MFN 09-074

Docket No. 52-010

Subject: Submittal of a Portion of Response to NRC Request for Additional Information (RAI) Letter 222 - Related to ESBWR Design Certification Application - Chapter 19 - PRA and Severe Accidents - RAI Number 19.2.4-1 S03, Supplemental Response

RAI Number 19.2.4-1 S03

Figure 1

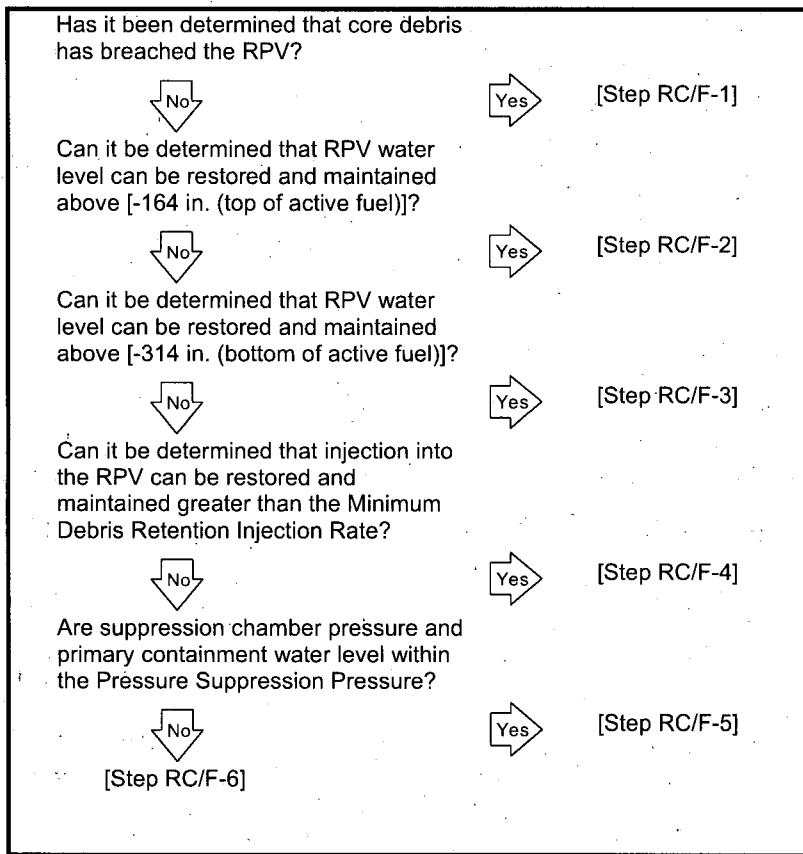
Step RC/F-1 – core breach results in initiation of BiMAC. BiMAC cools external debris and limits impact of ex-vessel steam explosion.

Step RC/F-2 – no impact/change as the event has been effectively terminated

Step RC/F-5 – vessel failure is likely and containment conditions are such that core debris ex-vessel will not cause containment failure. EPG assumes that containment conditions within Pressure Suppression Pressure assures no containment failure should vessel breach occur. Based on PRA insights, lower DW water level < 1 meter would be added to ensure limited impact on containment from ex-vessel steam explosion.

Step RC/F-6 – vessel failure is likely and containment conditions will not support core debris ex-vessel without challenging containment. Currently considering lower DW flooding to provide ex-vessel cooling as a last resort for prevention of vessel failure and ultimately containment failure.

- 1) Provide a caution on the use of DW sprays and preclude their use in step RC/F-5 where vessel failure is likely and DW level is below 1.5 meters.
- 2) Add lower DW level (1.5 meters) to the existing Pressure Suppression Pressure condition in RC/F-5 as an indicator of the containment's ability to handle vessel breach.
- 3) Do not preclude flooding of the lower DW to provide ex-vessel cooling in RC/F-6 as an alternative non-preferred method to avoid ex-vessel steam explosions by retaining core debris within the RPV.

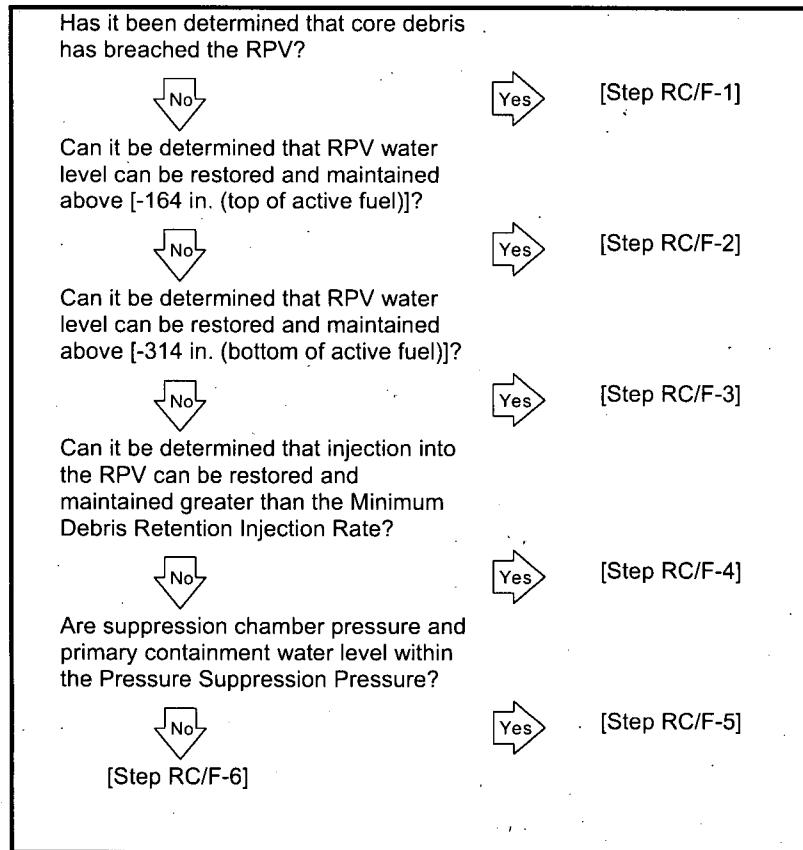
Lower drywell level below 1 meter will be added to this question. Limiting lower DW level minimizes probability of containment failure due to ex-vessel steam explosion following vessel breach.
